| Model: LCIT RT5030 (D452) | | Date: 21-Aug-09 | No.: RD452001 |
| Subject: Service Manual Correction: CIS Image Position Adjustment | | Prepared by: M. Abe | |

| Subject: New P/N for Tray Indication Decals | | Prepared by: K. Tsutsui | |

| Subject: Part Changes; Handle assembly and Shoe | | Prepared by: A. Takada | |

1.Exterior 1 (D452)

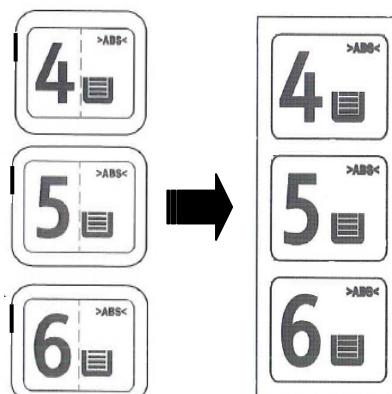
Change: Three separate tray indication decals for trays 4, 5, & 6 have been combined.

Reason: To reduce production cost

| Old P/N | New P/N | Description | Q'ty | Int | Page | Index |
|----------|-------------------|----------------------|------|-----|------|-------|
| | ▶ D4521310 | DECAL:PAPER TRAY:LCT | 1 | 0/0 | 2 | 26 |

Changed parts

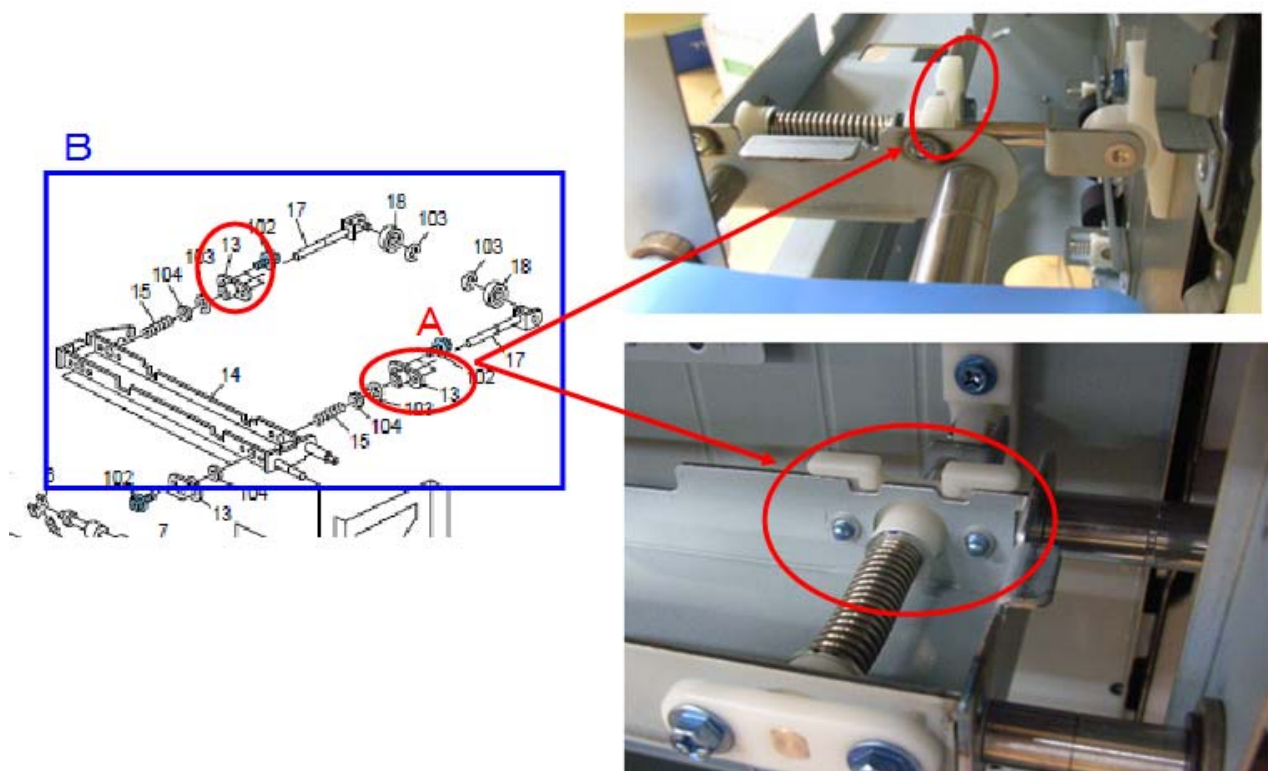
Change: Shape of the Handle assembly and Shoe

A : Shoe: Handle: Release

Shape of the Shoe was partially modified.

B : Handle: Ass'y

Handle was also modified in accordance with the shape change of the Shoe.
(Shape of the plate was also modified.)

| Old Part Number | New Part Number | Description | Q'ty | Int | Page | Index | Note |
|-----------------|-----------------|---------------------|------|-----|------|-------|------|
| D3553844 | D5163847 | Shoe:Handle:Release | 4 | X/O | 31 | 22 | - |

8.Tray 6 Unit 3 (D452)

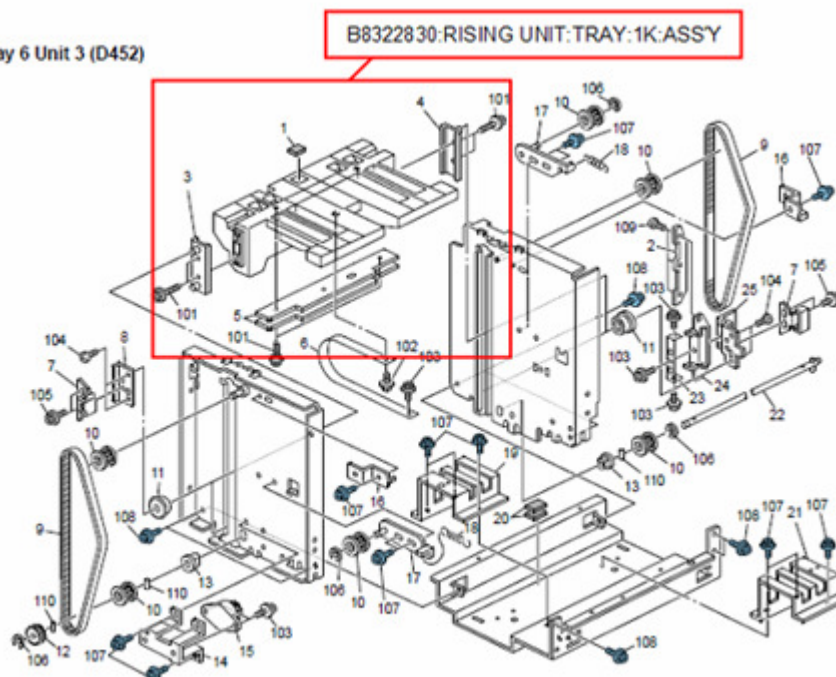
Change: The Tray Base Plate was added as a service part.

| Old Part Number | New Part Number | Description | Q'ty | Int | Page | Index | Note |
|-----------------|-----------------|---------------------------|------|-----|------|-------|------|
| - | B8322830 | RISING UNIT:TRAY:1K:ASS'Y | 1 | - | 16 | 26 | Add |

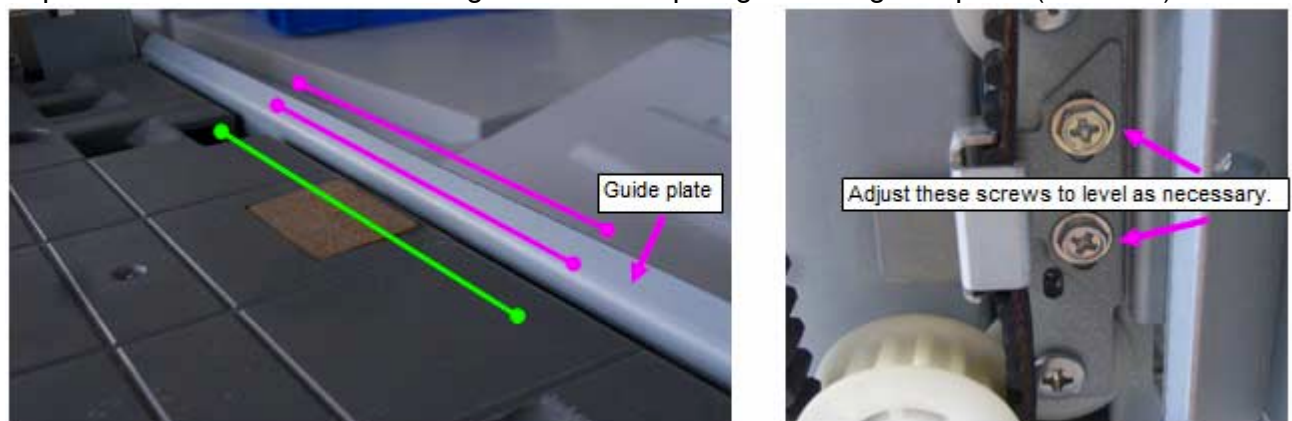
8. Replace with the new Base Plate (B8322830 RISING UNIT:TRAY:1K:ASS'Y).

NOTE 1: Make sure the Base Plate is positioned to the lowest position.

NOTE 2: For the Bottom Tray 6, work carefully to prevent the Stopper Belt from twisting.

9. To check if the Base Plate is level, lift up the Base Plate with your hands to the highest position so that the surface aligns with the top edge of the guide plate (+/- 1mm).

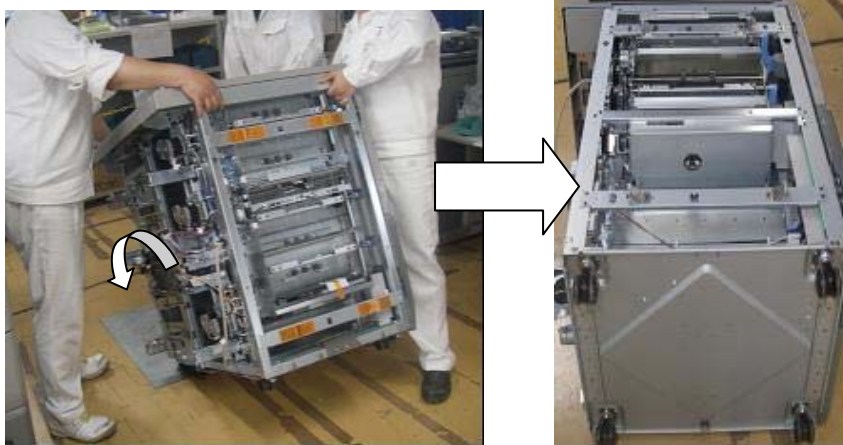
Replace the caster (p/n: AH012050) when a unit with a broken caster is found.
See the following page for the replacement procedure.

2. Lay the LCT down so that the side to which the mainframe docks faces up.

3. Replace the broken caster with a new one. (Screw x4)
